Office Action Summary	Application No. 10/540,872	Applicant(s) BROLUND, STIG-AKE	
	Examiner John Kreck	Art Unit 3673

DETAILED ACTION

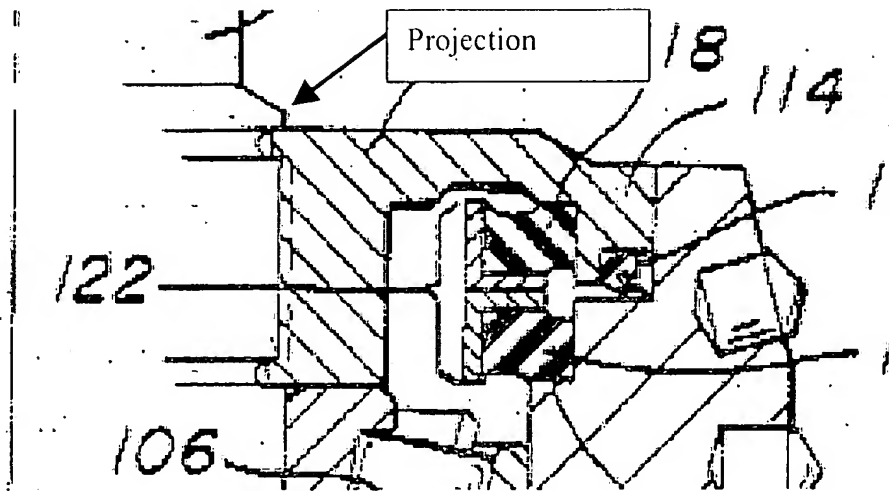
4. Claims 8 and 17 are rejected under 35 U.S.C. 102(b) as being anticipated by U.S. Patent number 4,509,607 to Saxman, et al. (see figure 3)

Saxman describes a roller cutter comprising a hub (24) having crushing members; a shaft (100); pair of lubricant seals (122,124); and a pair of covers

(110,112), each cover having a projection (see below) to lock the cover axially with respect to the shaft.

Saxman also describes the curved support surface (e.g. figure 3) and the shoulder as called for in claim 17.

Saxman lacks explicit disclosure of the projection arranged to lock the cover against rotation, however the dashed line in figure 3 (shown above) appears to represent a spline or other lock against rotation. See also text at 33-35. If it is deemed that Saxman fails to disclose the lock against rotation, it would have been obvious to one of ordinary skill in the art at the time of the invention to have made it so, since Saxman plainly describes the cover bonded to the non-rotating seal.
